I N D E X

Service Bulletin No.

Sea Bee Service News
Republic Aviation Corporation

FIGURE 5

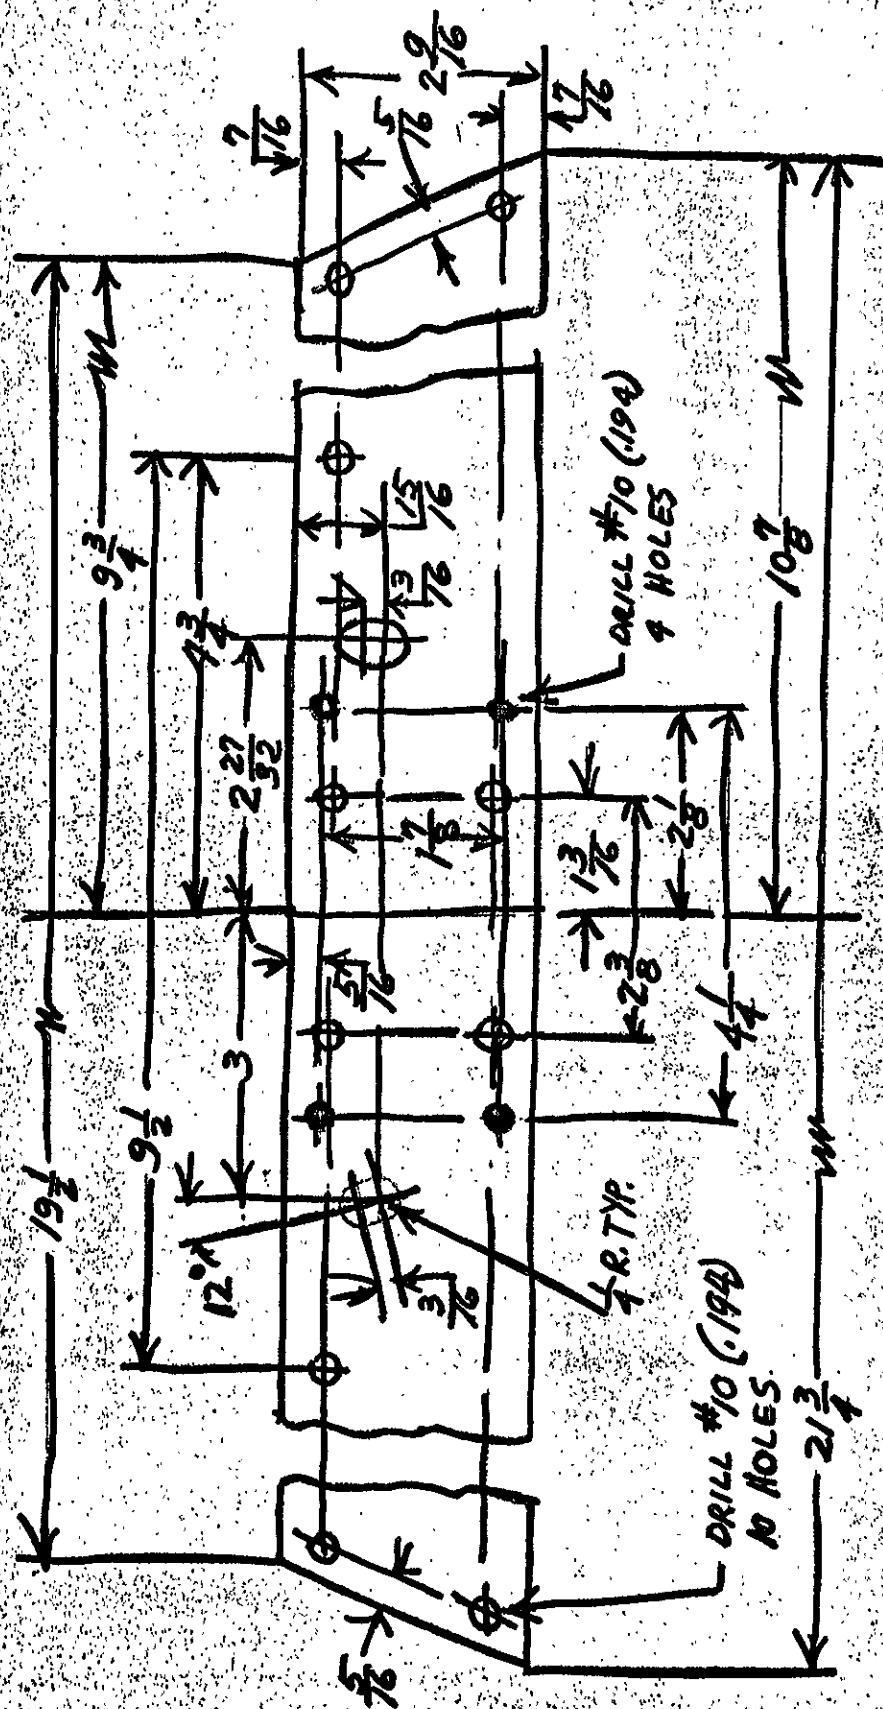
1. Referring to Figure 5 assemble yoke and quadrant assemblies on Fork and Spindle assemblies as follows:
 - a. Place 17F42152-1 washer over spindle.
 - b. Place yoke assembly over spindle.
 - c. Place Quadrant Assembly 17F42093-1 with Bushing Assembly 17F42175-1 over spindle.
 - d. Place Washer 17F42198-1 over spindle.
 - e. Place two Spring Washers 17F42045-2 over spindle.
 - f. Fasten assembly together with two AN960-C1016 washers, one AN310-10 nut and AN380-C4-4 cotter pin tightening nut sufficiently to resist a 20# to 25# side load applied at the bottom of the fork.
 - g. Apply AN-G-15 or equivalent waterproof grease at lubricating fittings on yoke.
 - h. Assemble old wheel, tire, etc. on this assembly.

FIGURE 7

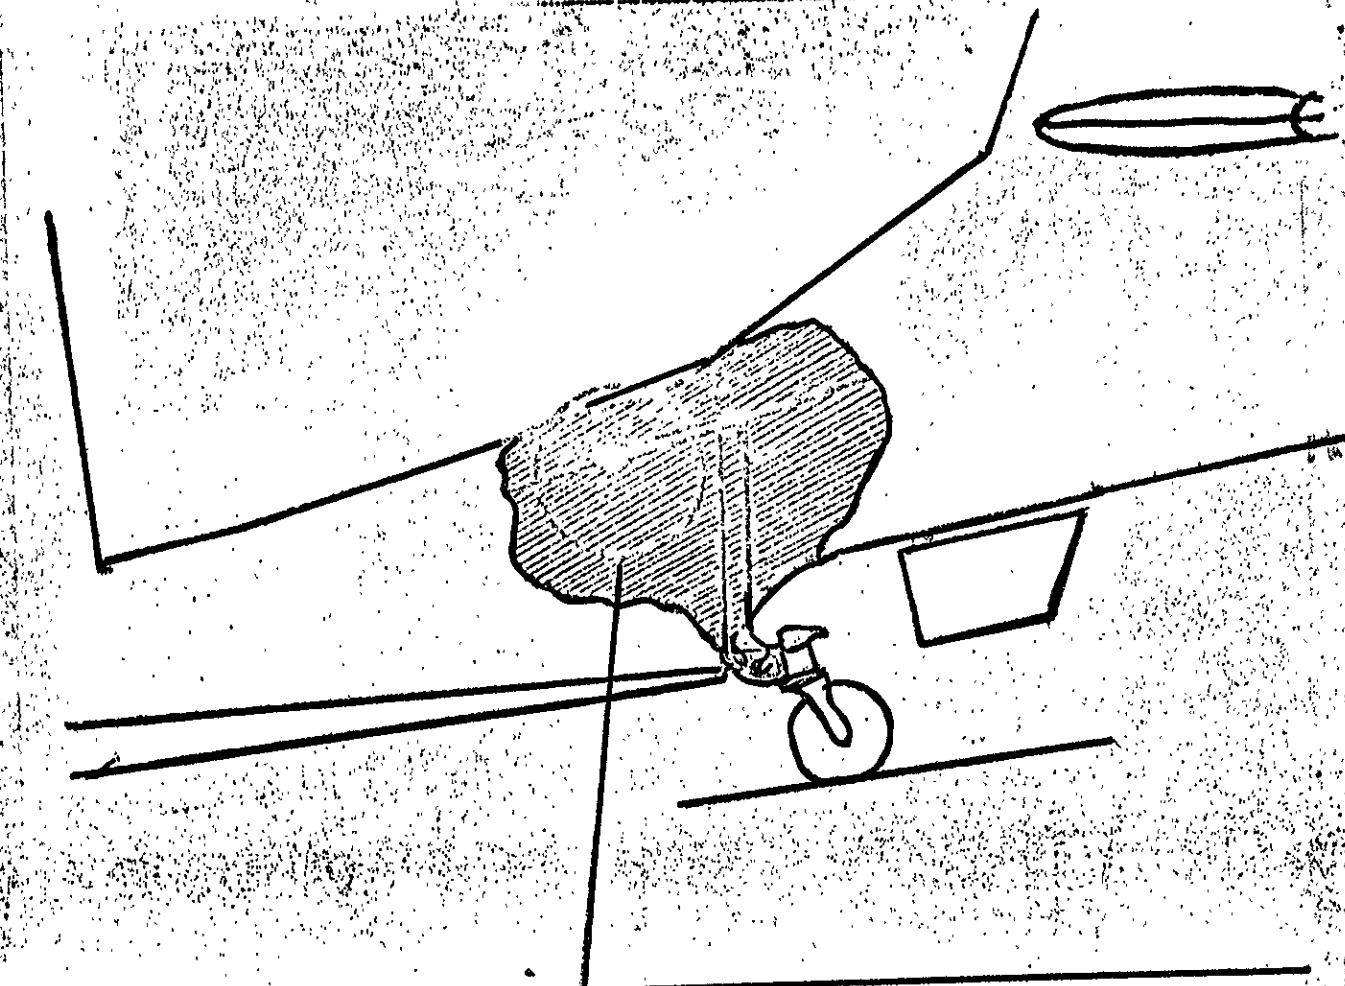
4. Place drilling template in place on aft side of bulkhead Sta. 230.5 referring to Figure 7 holding it in place with four bolts at existing fairlead holes and drill ten #10 (.194) holes thru bulkhead using template as guide. Also drill two 1/2 inch diameter holes thru bulkhead using elongated holes in template as guides. Use a rotary or rat-tail file to open these holes up to full elongated size. Remove template.

FIGURE 11

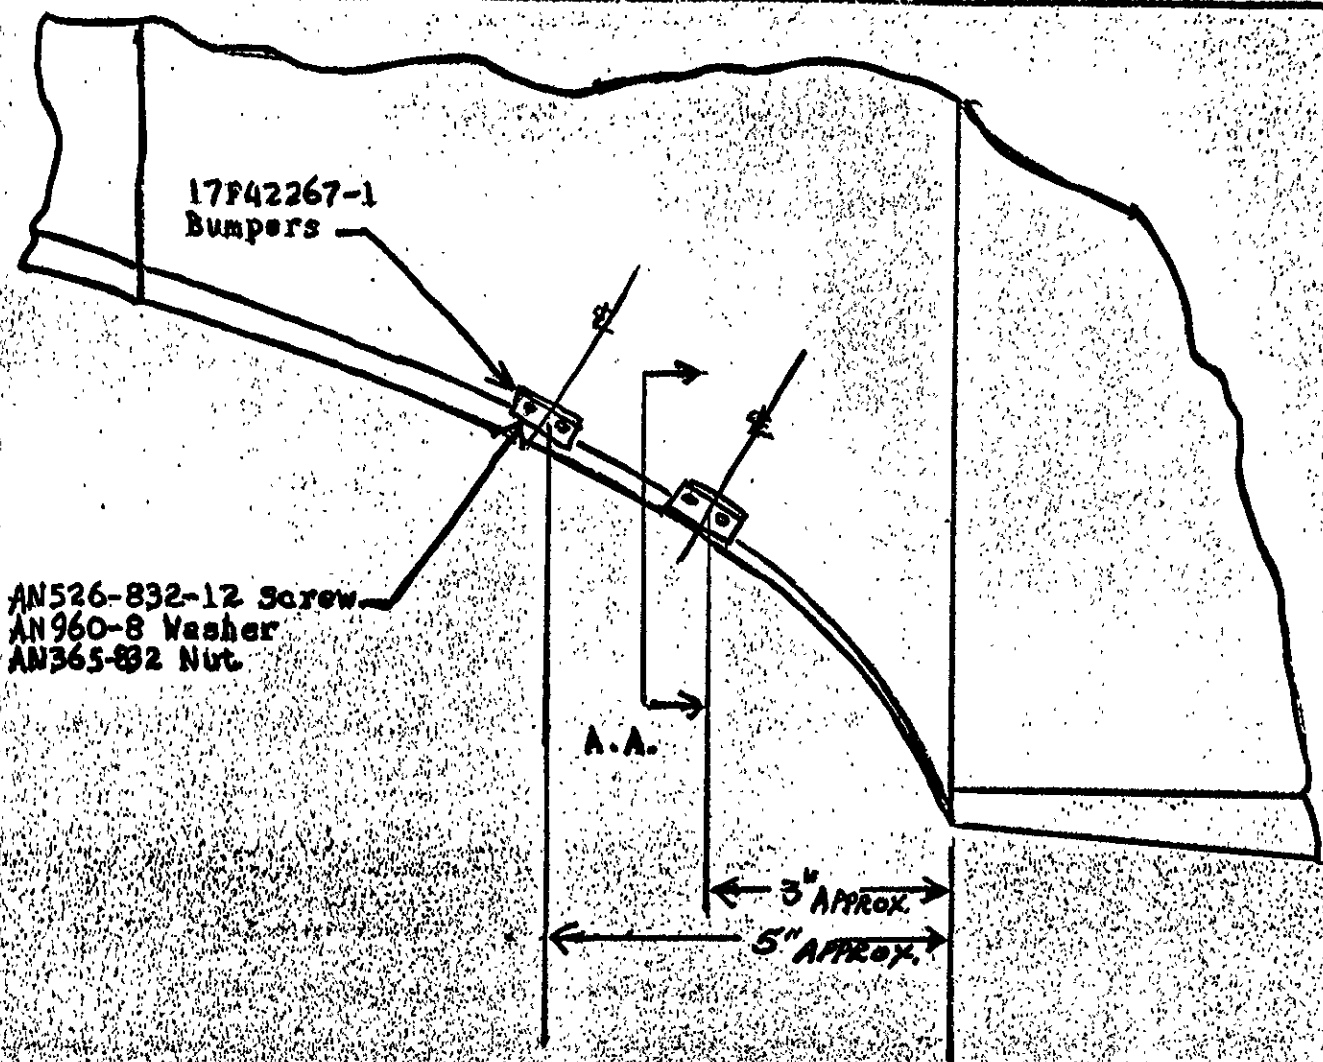
- f. Install two Bumpers 17F42267-1 as follows referring to Figure 11:
 - (1) Position of bumpers on right side of tail boom is to be determined by tail wheel fork in retracted and full swivel position. Mark location of interference with fork on tail boom.

Subject: Installation Wing Float Strut Braces

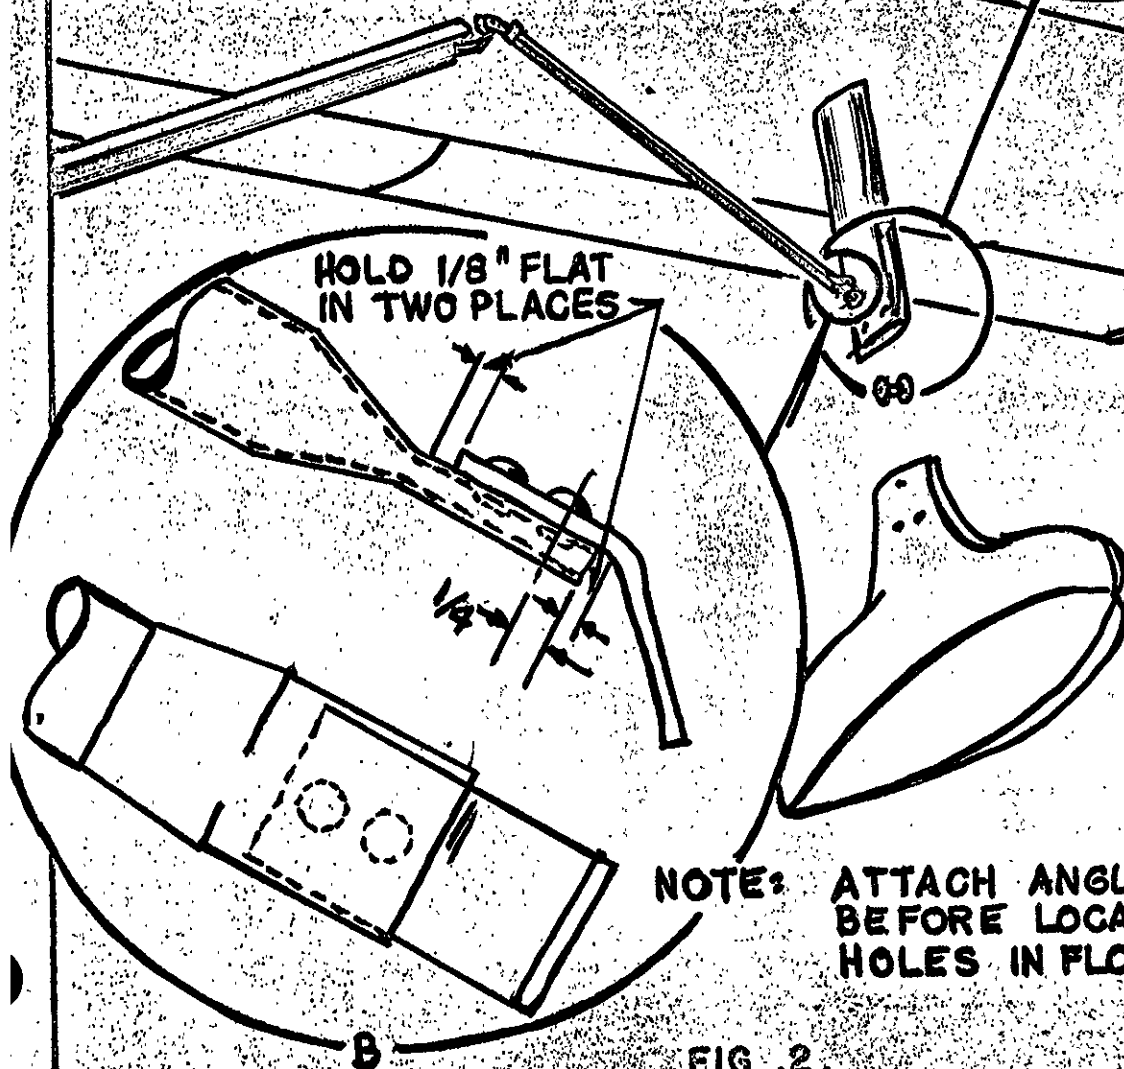
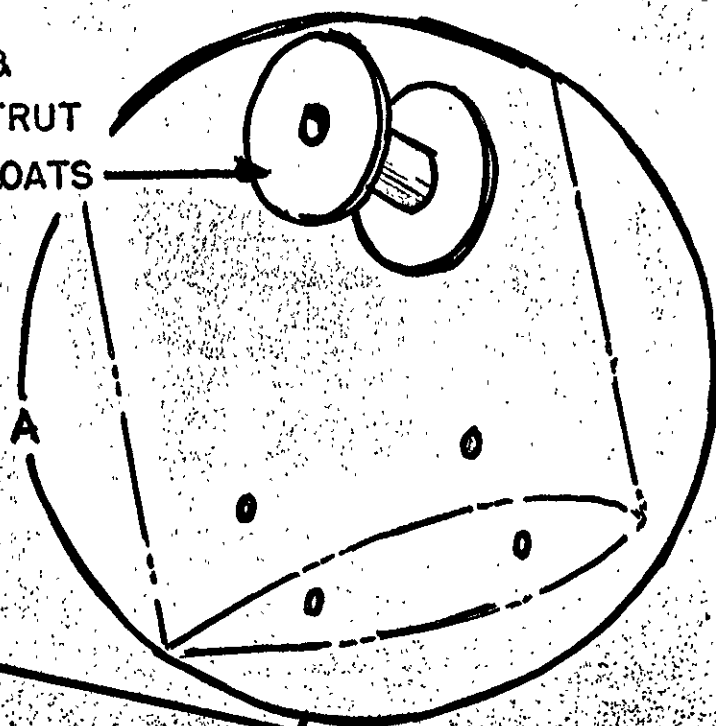
1. Place flaps in partially down position.
2. Remove four outboard bolts from fitting on inboard end of rear spar, leaving inboard end bolts as is.
3. Place 17W21028-1L angle in position shown on Figure 1. This is on the forward bottom side of the aft wing spar. Insert angle thru spar lightening hole. Install second from inboard end bolt thru existing hole in angle and clamp outer end of angle in position.
4. Mark location of seventeen holes to be drilled in spar web as shown on Figure 1 and drill thru web and angle with a #10 (.193) drill. Install AN3-5A bolts, AN365-1032 nuts and AN960-10 washers.

7. Install Float Strut Brace Assembly 17W22013-1L, Spacer 17W22011-1 and Lug 17W22010-1 as follows on the left wing referring to Figure 2.
 - a. Remove wing float.
 - b. Attach Strut Brace Assembly 17W22013-1L to forward side of wing lift strut fitting using same bolt which attaches lift strut to fitting.
 - c. Reinstall wing float, first placing Spacer 17W22011-1 and two Washers 17W2201L-1 over spacer in upper attaching hole in strut as shown on Figure 2 (a).
 - d. Put Lug 17W22010-1 in place as shown. Using pilot holes in lug as guides drill thru lug at end of strut with a #20 (.161) drill first being sure that there is at least 1/8 inch flat at the two locations shown on Figure 2 (b). Attach lug to strut with two AN441-5-7P rivets.
8. Repeat above installation on right side.
9. Make suitable entry in log books.
